MEMORANDUM

To: Salt Lake City Planning Commission
From: Eric Daems, Senior Planner, eric.daems@slcgov.com, 801-535-7236
Date: May 24, 2023
Re: Modifications to Design Review Approval for Collaborative 1135 (PLNPCM2022-00327)

Design Review

PROPERTY ADDRESS: 1135 South West Temple Street
PARCEL ID: 15-12-431-002-0000
MASTER PLAN: Central Community, Ballpark Station Area
ZONING DISTRICT: CC Corridor Commercial

Proposed Site Plan

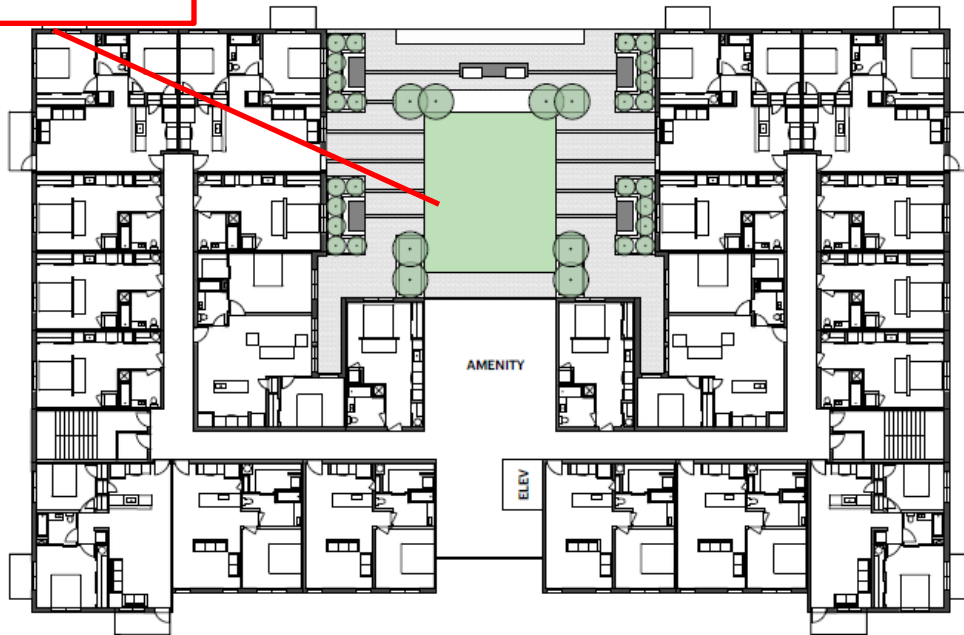
Commentary: The proposed site plan has been modified to incorporate parking within the building. It also has been revised to allow for a more diverse mix of unit types. The previous approval was for 88 studio units. The new proposal is for 68 units including 30 studio, 18 1-bedroom, and 20 2-bedroom units. The new building also incorporates an outdoor terrace on the 2nd floor as depicted below.

Proposed North and South Elevations (sides)

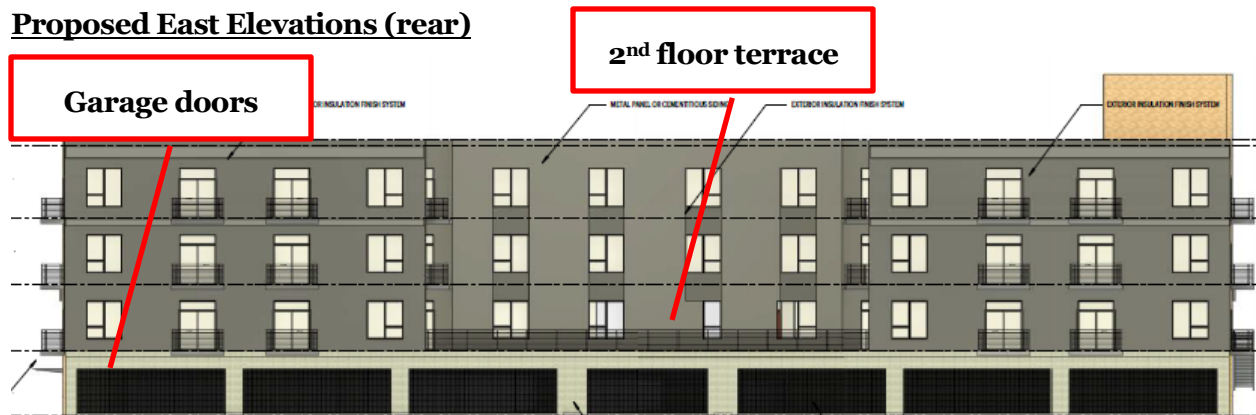
Commentary: The proposed changes add to the length of the building, but the changes are inconsequential as the sides of the building will be buffered by landscaped yards where none would be required.

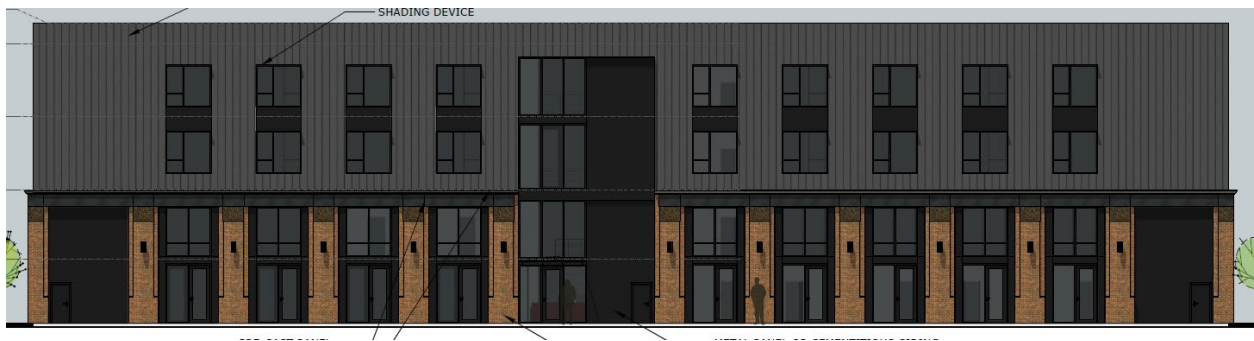
Commentary: The modifications to the rear façade are the most substantial as the building now incorporates all parking within a garage. The rear elevation now includes 7 garage doors to access

parking stalls directly from the alley. The rear façade also now includes an outdoor terrace for residents on the 2nd floor.
